## Washington Public Power Supply System

Subject: **NUCLEAR PROJECT 3  
CHANGES TO THE QUALITY ASSURANCE  
PROGRAM DESCRIPTION**

Since the initiation and issuance of Amendment 5 to the FSAR, additional Supply System organizational changes have been made. These changes are detailed in Attachment 2 which presents a mark-up of FSAR Chapter 17 to show the changes which will be published in a future amendment.

## ATTACHMENT I

17.1.13

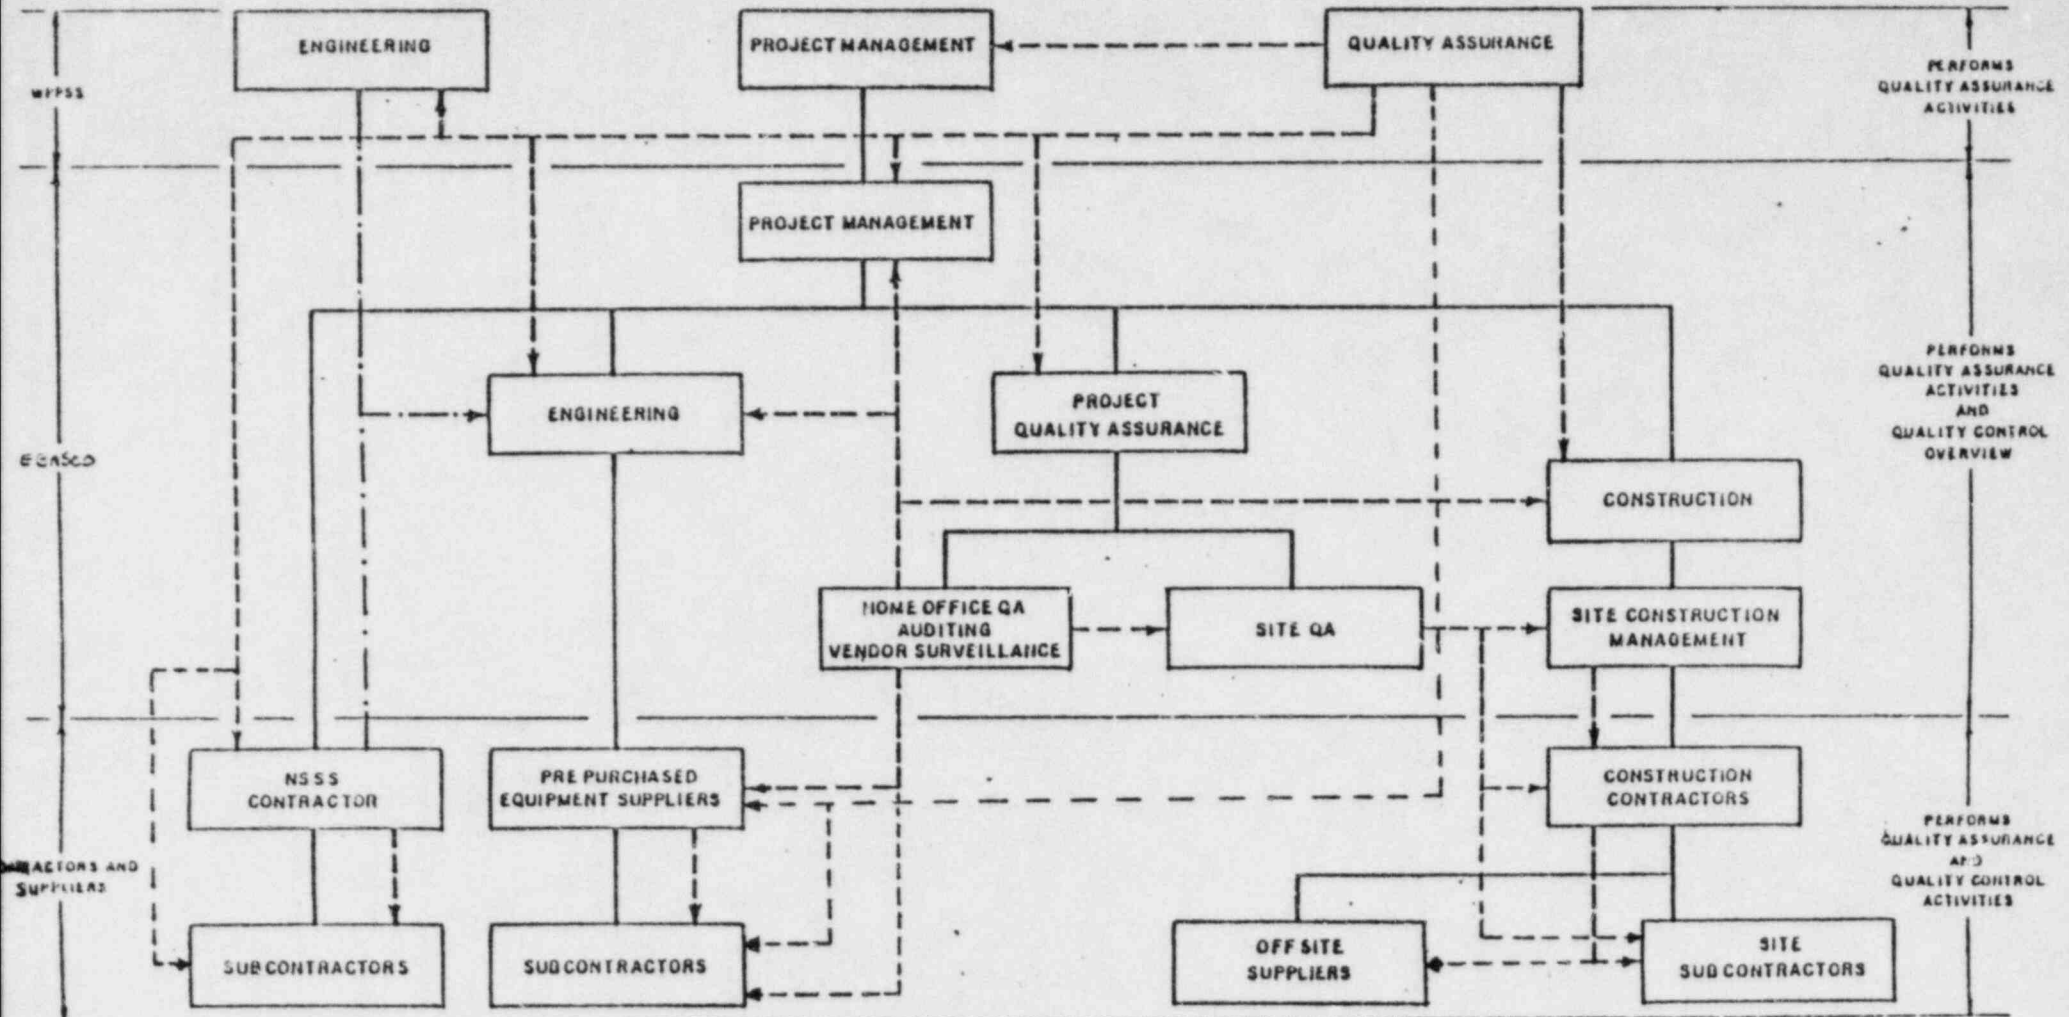
**- ADDING THIS FIGURE -**

ADDING THIS FIGURE
